Access Compliance Report

Public Rights-of-Way

(Curb Ramps)

Intersection ID: 8672	Main Street: BENNETT_ST	Cross Street: HILLSBORO_AV	Location: NE
ADA ID: 29D83B8A9641	Ramp Type: BlendTrans1	Initial Pass/Fail: Fail	Overall Compliance: No
		Severity Score: 8.75

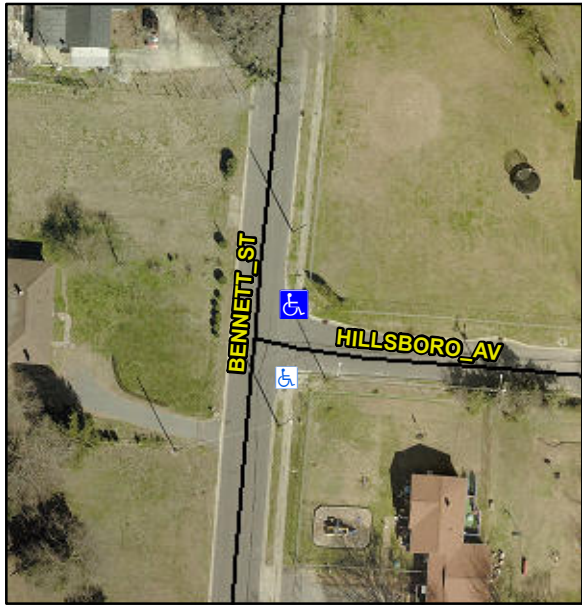
Codes/Mitigation Info/Possible Solution			Field Measurements/Component Compliance					
	Possible Solutions:		Compliance	Description	Data	Compliance	Description	Data
	Remove & Replace Curb Ramp With Two New Directional Ramps or Equivalent.		N/A	Ramp Length (in)	78.5	Yes	BlendTrans Slope (%)	2.7
			No	Ramp Width (in)	36.0	Yes	BlendTrans XSlope (%)	0.6
			N/A	Flare Type LT	N/A	N/A	Flare Type RT	N/A
			N/A	Flare Slope LT (%)	N/A	N/A	Flare Slope RT (%)	N/A
			N/A	Flare Traversable LT?	N/A	N/A	Flare Traversable RT?	N/A
			N/A	Landing Length (in)	N/A	N/A	DWS Provided?	N/A
			N/A	Landing Width (in)	N/A	N/A	DWS Contrast?	N/A
			N/A	Landing Slope (%)	N/A	N/A	DWS Length (in)	N/A
			N/A	Landing X Slope (%)	N/A	N/A	DWS Full Width?	N/A
<p>Surveyor Notes:</p> <p>NO RT SW</p> <p>PROW/ADA:</p> <p>Not Found, R304.5.1</p>			N/A	Landing Curb? (Y/N)	N/A	N/A	DWS Offset (in)	N/A
			N/A	Shared Landing?	N/A			
			N/A	Gutter Ponding?	N/A	N/A	Gutter Slope (%)	N/A

N/A	Gutter Lip Ht (in)	N/A	N/A	Gutter X Slope (%)	N/A
			N/A	Painted X Walk1?	No	N/A	Painted X Walk2?	N/A
				X Walk 1 Direction	To S		X Walk 2 Direction	N/A
				X Walk 1 Width (in)	N/A		X Walk 2 Width (in)	N/A
				X Walk 1 Slope (%)	3.3		X Walk 2 Slope (%)	N/A
				X Walk 1 X Slope (%)	2.2		X Walk 2 X Slope (%)	N/A
			N/A	Ramp inside XWalk1?	N/A	N/A	Ramp inside XWalk2?	N/A
			Road Slope (%)	2.2		Clear Space?	N/A	
			Road X Slope (%)	3.3	N/A	Clear Space to XWalk (in)	N/A	
		N/A	Any Obstructions?	N/A	N/A	Storm Grate/Utility Hazard?	N/A	
			Obstruction Type			Storm Grate/Utility Type		
					N/A			N/A
						Yes	Surface Condition? (G/P)	Good
						No	Curb Slope (%)	17.4
